2	PLAN	DESSINE PAR : SFOURMY	LE : 12/08/98	REFERENCE
1	CAD	VERIFIE PAR : VALABLE A L'INDICE :	LE : Visa:	53220997

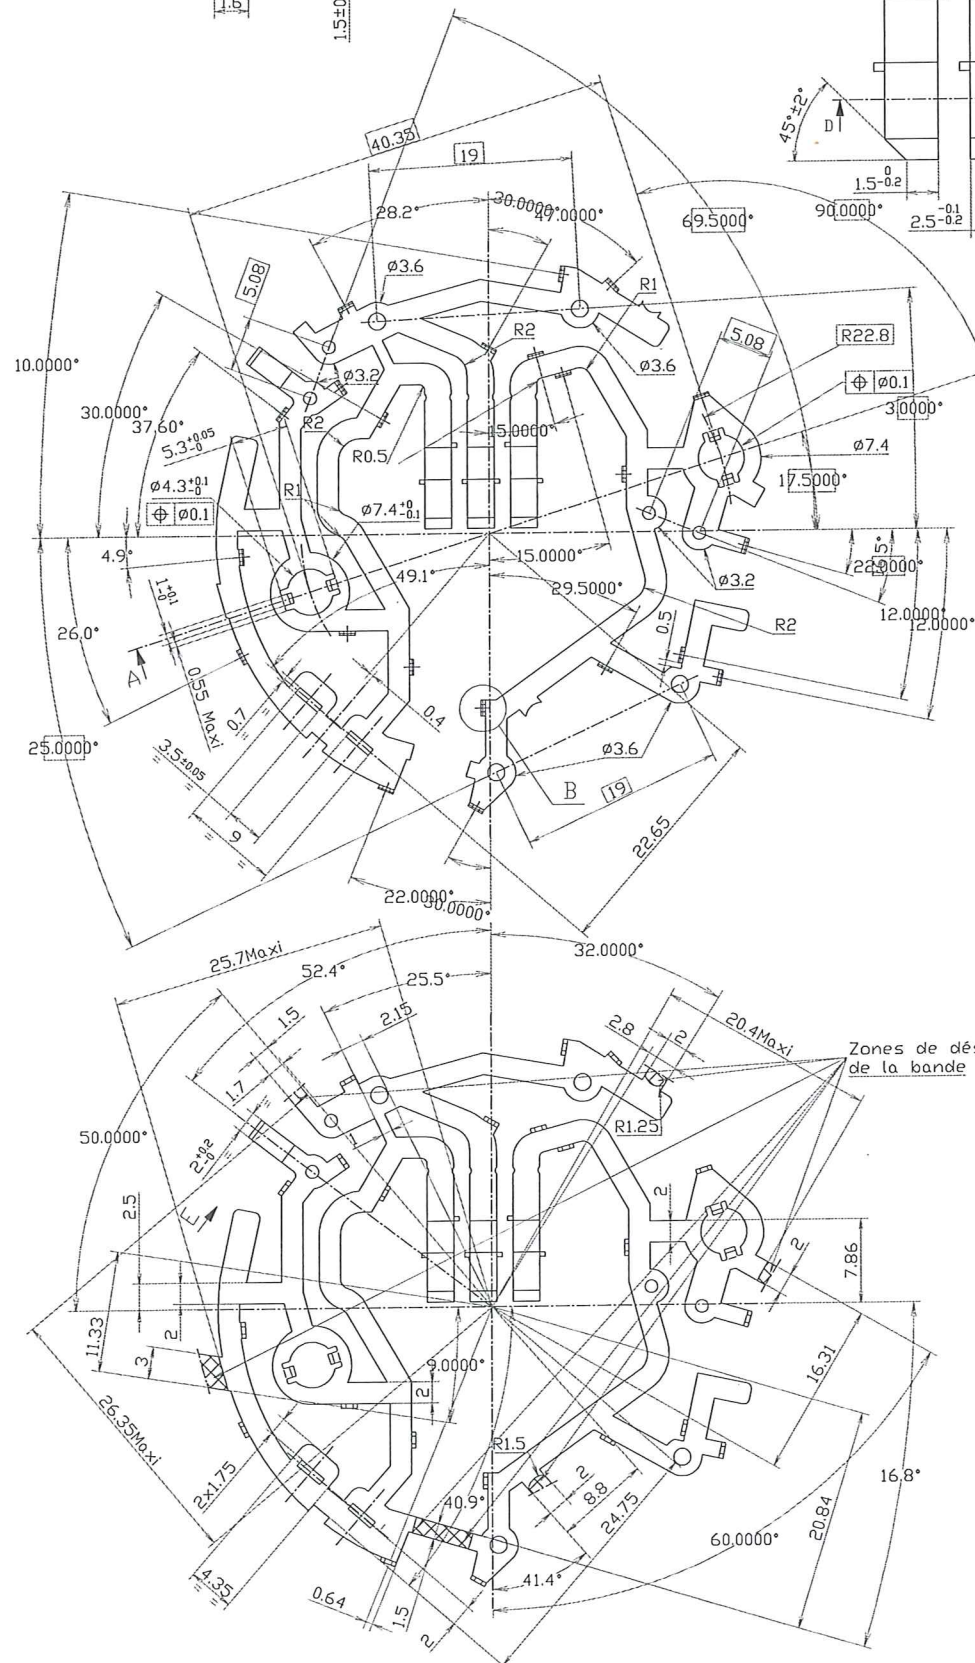
T.T.	03/09/13	Ajout cotes de 3.5 en coupe D-D	10
T.T.	10/01/13	Ajout variante matière	15
P.G.	30/08/05	Cote de 4.3 passe à 5.1	1
T.T.	14/05/03	45±1, 1.5+0/-0.1 devient 45±2, 1.5+0/-0.2 coupe D-D	13
T.T.	15/10/02	Chanfrein à 45° sur une languette (coupe D-D)	13
		Annulation de la modif indice 11 (cote de 2 était 3)	
R.M.	24/01/02	Elargissement de la piste au niveau de la soudure cage balai (cote de 3 était 2)	13
D.B	03.11.99	Modifié forme des bornes (ajouté cote de 2.8 0/+0.1, changé cotes : 1.9 0/+0.1, 2.4, 1.1 étaient 2.5 0/+0.1, 2.1, 0.8).	10
D.B	16.08.99	Ajouté cote de 0.5	9
D.B	15.03.99	Changé cote : 20±5° était 21±5°	8
D.B	01.03.99	Supprimé encadré du "développé approximatif". Créé référence pièce 53220997	7
D.B	24.02.99	Supprimé cotes : 2x2.75, 2.73. Ajouté cotes 9, 0.4	6
D.B	15.01.99	Changé cotes 21, 3.5 0/+0.15, 0.8, 0.55 Maxi, 21±5°, 26° 25.5°, 2.15 étaient 2.1±0.05, 3.5±0.05, 0.8±0.05, 0.5 0/+0.05 21° 0/-1°, 30°, 23.6°, 2.78. Pt A15 (-23.14;-11.29) était (-22.36;-12.78). Déplacé une zone de déshuntage.	5

Ajouté "Aucune bavure détachable"	
D.B	23.12.98	Ajouté reprise de masse, harpons sur pattes connecteur, vue svt C coupe D-D. Etat H14 était H12	4
D.B	23.11.98	Supprimé cote de 40°. Remplacé verrou PTH par trou rectangulaire	3
D.B	01.09.98	Verrou PTH : 45° mini était 60° mini, ajouté 0.8 maxi, 2.6 était 2.6±0.05. Ajouté encadré "développé"	2
S.F	12.08.98	Création de plan	1
Dess	Date	Nature des modifications	In
